July 24, 2003

I am writing you this letter to provide you with comments on your planned restoration for the Little Island Salt Marsh in West Falmouth. In this letter, I also attempt to explain and summarize some of the complex engineering and permitting issues that surround this project, so others interested in this project can better understand them.

Figure 2. Summary of existing features and proposed new pipe elevation for the culvert replacement at Little Island Marsh.

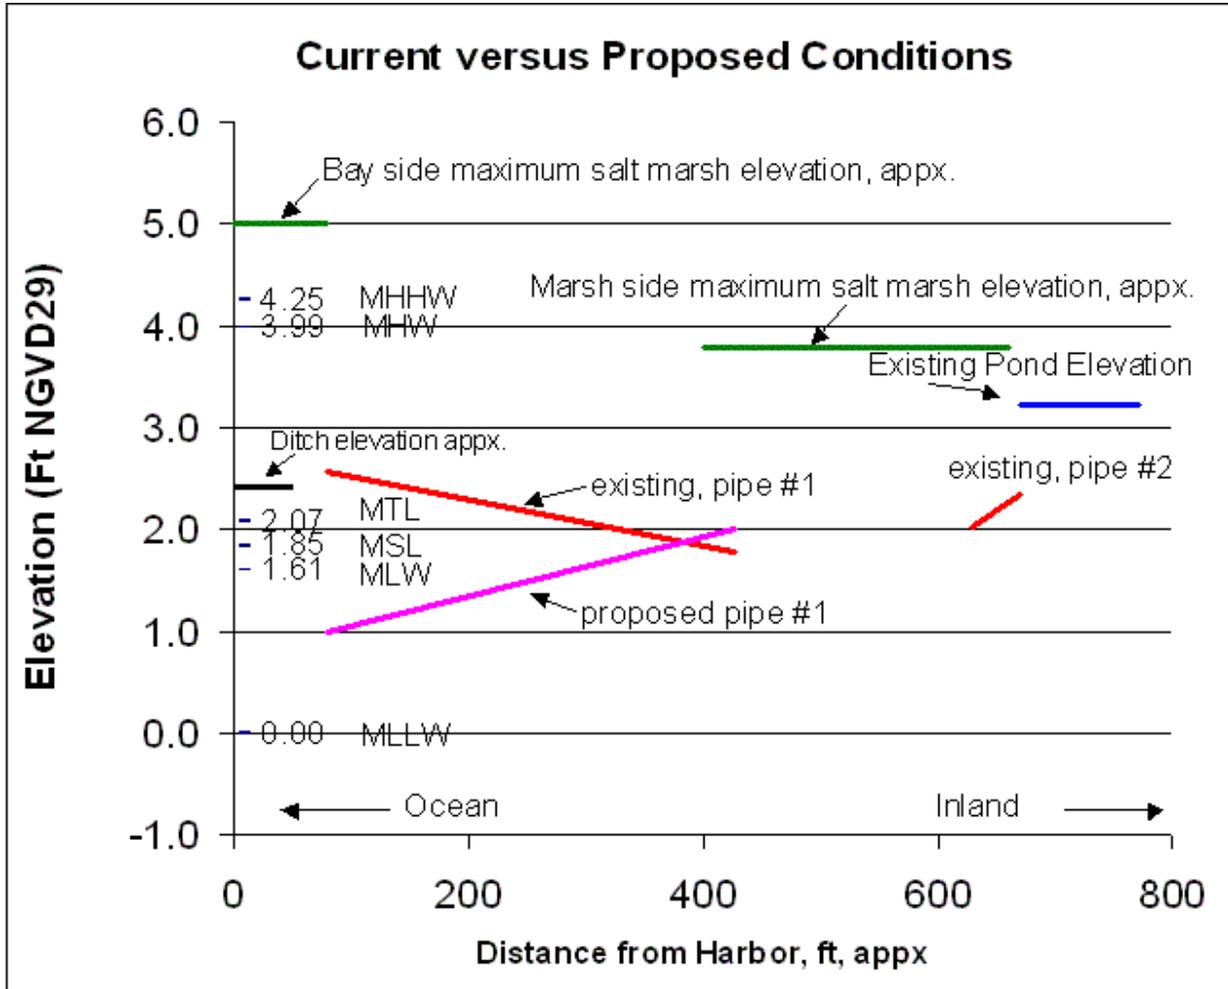
culvert replacement permitting is generally considerably easier, particularly in a wetland restoration project. However, because the proposed pipe inverts are being changed (the ocean side would be lowered from 2.57 feet to 1.0 feet, and the inner raised to 2.0 feet), this project would in fact drain the first marsh segment somewhat and change the hydrography of the marsh. This would require an U.S. Army Corps permit. Because the ocean invert was higher than the marsh invert, when the old culvert was operational, the water level in the marsh could never drop below 2.57 feet. With the new pipe elevations, the first segment would drain 2.0 feet, or a little over half a foot. The second marsh segment, however, could never drain below 2.34 feet, the invert of the second marsh segment culvert, which is not being replaced.

One additional issue must be considered with the proposed designs. The existing pipe elevation to the ditch entering West Falmouth Harbor is 2.57 feet. The proposed new invert elevation is 1.0 foot. However, the ditch base elevation appears to be around 2.5 feet MLW near the mouth of the culvert, and does not drop to 2.0 feet for at least 20 feet, and does not drop to 1.0 feet for at least 80 feet according to the plans. For the pipe not to be buried and to operate, the tidal ditch would need to be deepened to a 1-foot elevation. Because this ditch is within Massachusetts tidelands, this dredging would require a Chapter 91 permit, and considerable additional expense. Moreover, with the entrance of the pipe so far below the grade of the surrounding sediments, and the stability of sidewalls in a tidal environment questionable, and there would be serious questions as to whether the pipe opening would be buried. This might make obtaining a Chapter 91 dredging permit more difficult to obtain.

A simpler solution would be to raise the invert elevation on the bay side. A careful study of the Woods Hole Group May 2003 report shows that the ocean-side invert elevations are completely irrelevant in predicting tidal flushing. That is, for any pipe diameter and given salt marsh side pipe invert elevation, tidal flow is the same, no matter what the harbor invert elevation. In other words, Woods Hole Group concludes the slope of the pipe and lowest invert elevation have no effect on water exchange. Under closed conduit model, only the maximum invert elevation at either end of the pipe is relevant. That is why, even with an upwards sloping pipe in the existing conditions, unobstructed existing design flow matches flow in the May 2003 report for a marsh invert between 2.0 and 3.0 feet. A graphical representation of closed and open channel conditions is illustrated in Figure 4.

The proposed new invert design has a maximum invert elevation (at either end) of 2.0 feet, whereas the existing maximum invert elevation (at either end of the pipe) is 2.57 feet. This reduction in maximum invert elevation is the basis of the calculation for the projected improvement in tidal flushing by the new designs. Specifically, a five-fold increase in tidal flushing is expected during neap tides, and 50 percent increase is expected during spring tides over the existing pipe if it were unobstructed because of this 0.57-foot decrease. Of course, installation of a new unobstructed pipe, even at existing invert elevations, would be a considerable improvement over the nearly completely blocked pipe conditions that now exist, and are adversely affecting the salt marsh.

In conclusion, if you and your neighbors were to fund this project, the Buzzards Bay Project would endorse your effort to restore the marsh by replacing the existing obstructed 1-foot diameter pipe with a new 1-foot diameter pipe. You may however wish to reconsider the proposed 1.0-foot pipe invert elevation to West Falmouth Harbor to avoid additional dredging and permit costs, and the likelihood the culvert entrance will become buried. Keeping the pipe size and invert elevations identical to current conditions will result in less permitting requirements. Changing invert elevations and increasing pipe size will require additional permitting (e.g. Army Corps permits), but is achievable, and will provide more flushing benefits to the salt marsh.

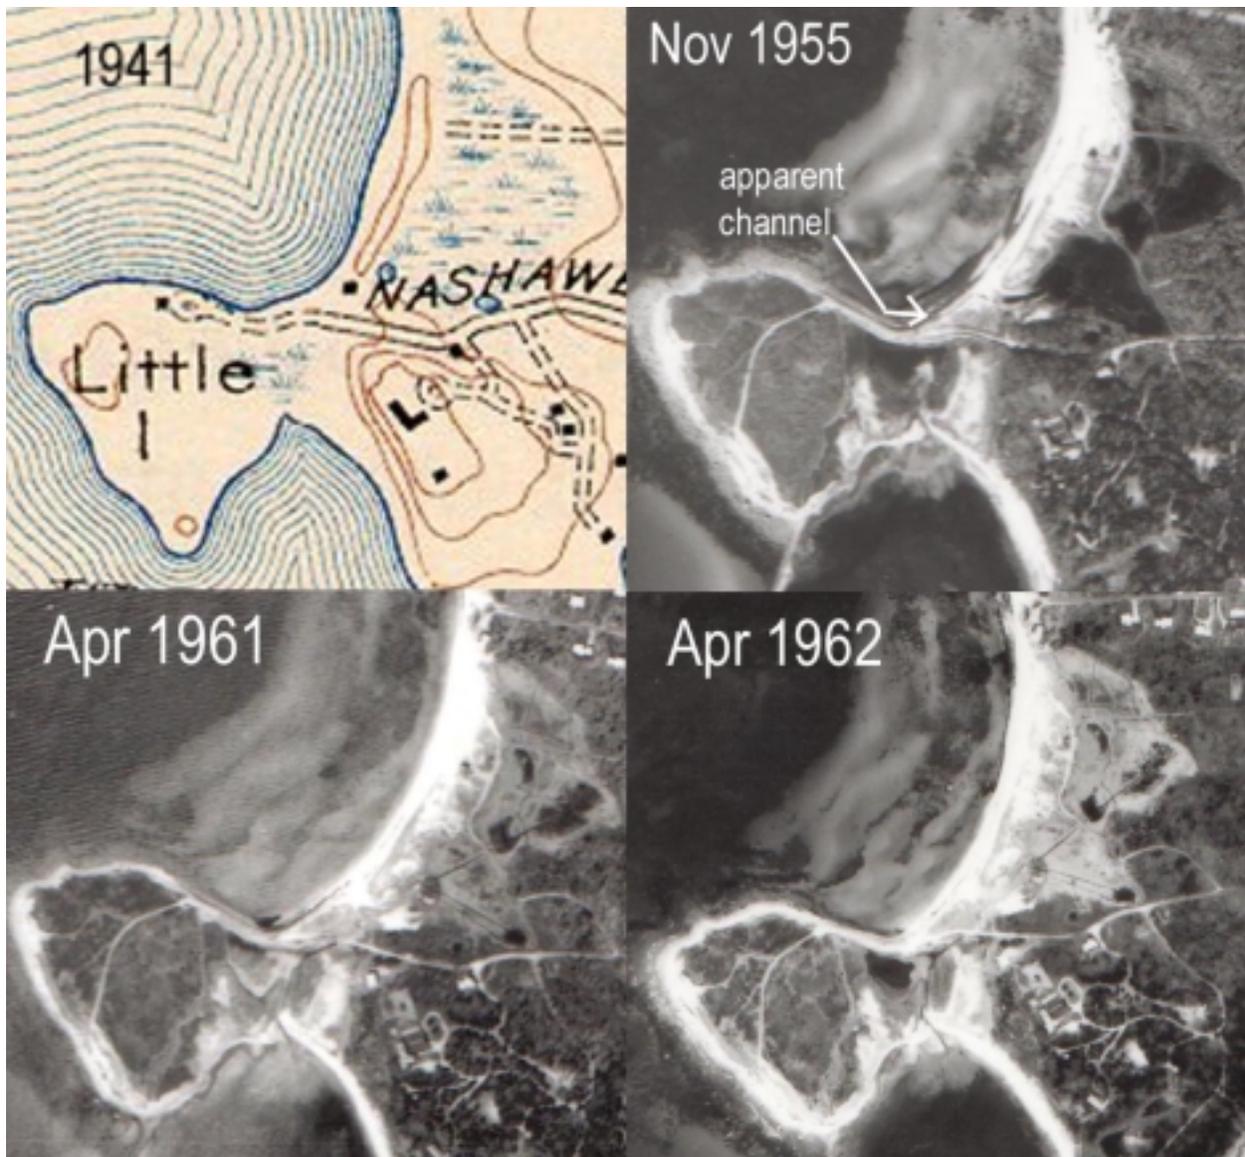
We have been informed that there was debate about what vegetation existed at the site prior to the installation of the culvert. We have reviewed historic photographs, topographic maps, and other information. This site, like many along the west coast of Falmouth glacial moraine, may have once been a white cedar kettle hole swamp in past centuries that became a salt marsh as sea level rose. (Sea level has continued to rise since the last ice age 10,000 years ago, and the rise has been one foot per century for the past several hundred years). A 1941-dated USGS topographic chart (Figure 3) shows the site a wetland, consistent with today's salt marsh distribution. These older topographic maps typically do not show small tidal streams, so it is unknown what channel, if any, existed to the wetland. However, our earliest aerial photographs on file dated November, 1955 shows an inundated marsh with an apparent natural channel north of Little Island Road. Ironically, this is at the location of a structure, possibly a cottage, in the 1941 topographic map. Although shown on the 1941 map, features on topographic maps are not always current with their date of issue, and this structure may have been destroyed and the channel created by the 1938 hurricane, or a subsequent storm. This channel may have again been blocked by sand transport or hurricanes in the late 1950s, and by 1961 and 1962, photographs show the channel apparently again blocked or covered by south migrating sand dunes (Figure 3).

If the existing culvert remains obstructed, the site will not revert to upland. Rather, the site will remain a brackish salt marsh until rising sea level or another storm eventually break through the beach and dunes. Currently this beach in front of the central portion of the marsh is eroding, and the vegetated dune crest has receded inland 12 feet during the period 1994 to 2002.

Figure 4. Comparison of open channel versus closed conduit conditions.

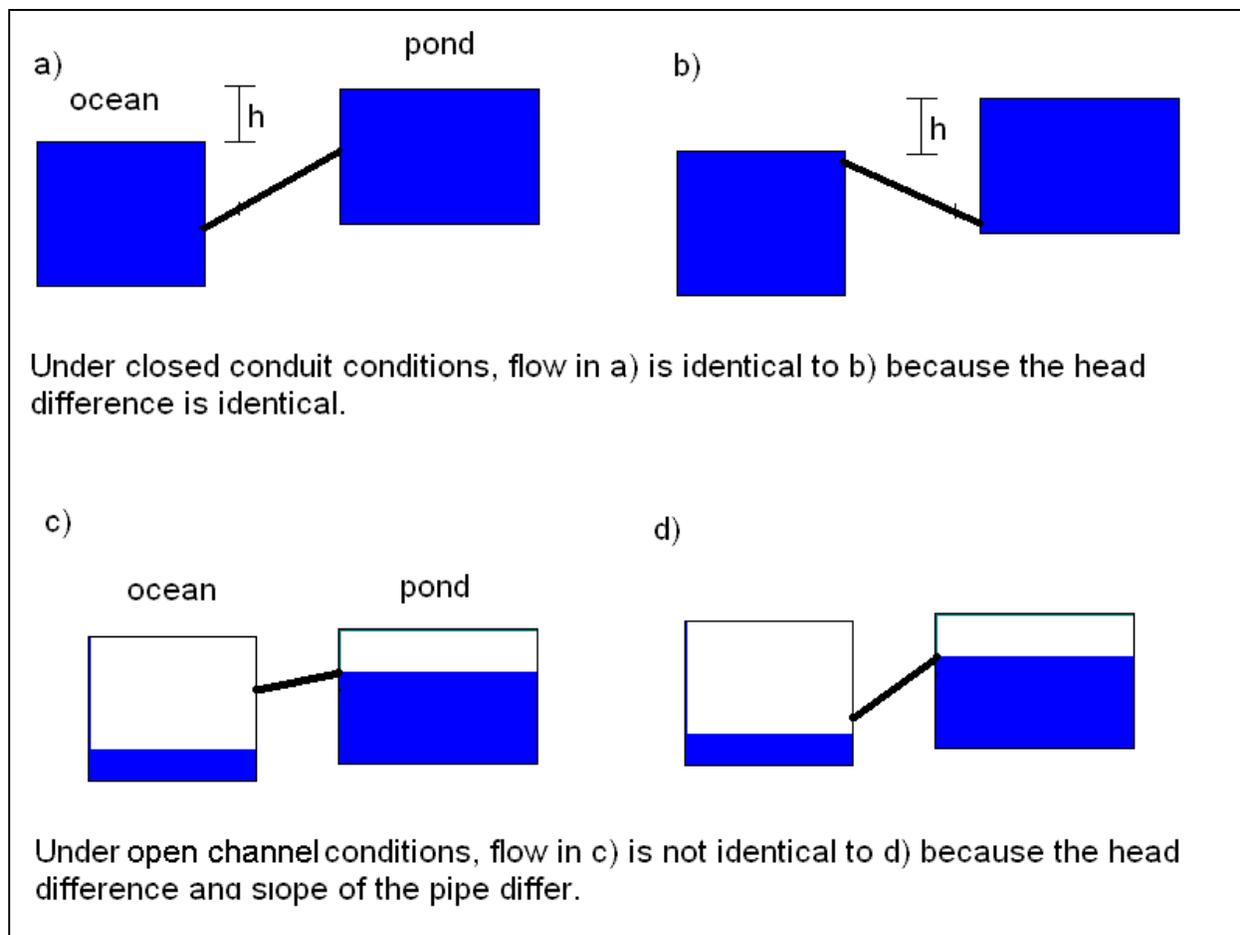
Thus, with closed conduit assumptions, the ocean side invert can be raised to the marsh side invert elevation (a level pipe), without affecting estimated tidal exchange. For that matter, both inverts can be kept the same to expedite permitting, but the existing harbor invert of 2.57 feet will then become the limiting factor controlling tidal exchange.

It appears that closed conduit conditions will not always be met because Woods Hole Group, in their May 2003 report, state that the marsh would be drained to the base of the pipe. By definition, the system will therefore not always behave like a closed conduit, and other factors like pipe slope will affect water movement. However, we do not know whether the duration of the “open channel” conditions will appreciably affect the conclusions of this study. Also, the 2002 report acknowledged that the presence of the second culvert affects the analysis, and the study treated the marsh system as a single unit. Clearly, the two-thirds of the marsh area beyond the second culvert will never drain below 2.34-foot level of the inner pipe invert.
